Access Compliance Report

Public Rights-of-Way

(Curb Ramps)

Intersection ID: 9655	Main Street: N_GRAHAM_ST	Cross Street: CONCORDIA_AV	Location: E
ADA ID: 0A3B3F16E958	Ramp Type: PerpDiag	Initial Pass/Fail: Fail	Overall Compliance: No
Codes/Mitigation Info/Possible Solution		Field Measurements/Component Compliance	
Severity Score: 48.75

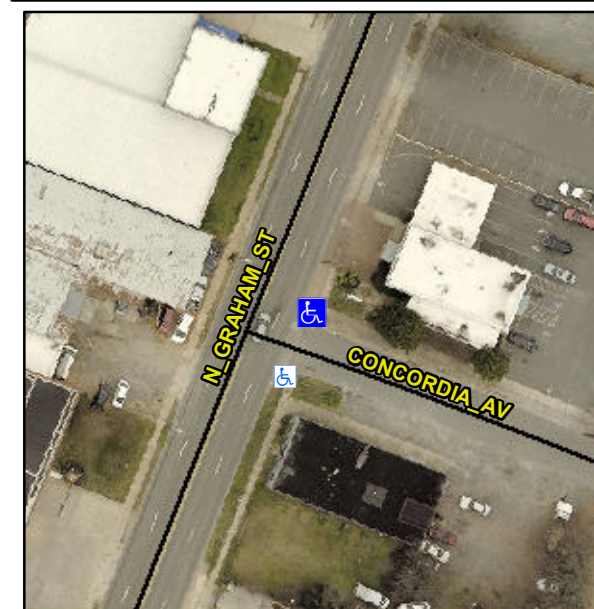
Not Found, R304.5.1, R304.2.2, R302.7

Compliance	Description	Data	Compliance	Description	Data
N/A	Ramp Length (in)	29.5	No	Ramp Slope (%)	12.9
No	Ramp Width (in)	47.5	Yes	Ramp XSlope (%)	1.6
N/A	Flare Type LT	N/A	N/A	Flare Type RT	N/A
N/A	Flare Slope LT (%)	N/A	N/A	Flare Slope RT (%)	N/A
N/A	Flare Traversable LT?	N/A	N/A	Flare Traversable RT?	N/A
N/A	Landing Length (in)	N/A	N/A	DWS Provided?	N/A
N/A	Landing Width (in)	N/A	N/A	DWS Contrast?	N/A
N/A	Landing Slope (%)	N/A	N/A	DWS Length (in)	N/A
N/A	Landing X Slope (%)	N/A	N/A	DWS Full Width?	N/A
N/A	Landing Curb? (Y/N)	N/A	N/A	DWS Offset (in)	N/A
N/A	Shared Landing?	N/A			
N/A	Gutter Ponding?	Yes	N/A	Gutter Slope (%)	N/A
N/A	Gutter Lip Ht (in)	N/A	N/A	Gutter X Slope (%)	N/A
N/A	Painted X Walk1?	No	N/A	Painted X Walk2?	No
	X Walk 1 Direction	To NW		X Walk 2 Direction	To SW
N/A	X Walk 1 Width (in)	N/A	N/A	X Walk 2 Width (in)	N/A
	X Walk 1 Slope (%)	5.8		X Walk 2 Slope (%)	3.0
	X Walk 1 X Slope (%)	0.8		X Walk 2 X Slope (%)	2.4

N/A	Ramp inside XWalk1?	N/A	N/A	Ramp inside XWalk2?	N/A
	Road Slope (%)	2.5	N/A	Clear Space?	N/A
	Road X Slope (%)	3.7	N/A	Clear Space to XWalk (in)	N/A
N/A	Any Obstructions?	N/A	N/A	Storm Grate/Utility Hazard?	N/A
	Obstruction Type			Storm Grate/Utility Type	
		N/A			N/A
		No		Surface Condition? (G/P)	Poor

Remove & Replace Curb Ramp With Two New Directional Ramps or Equivalent.
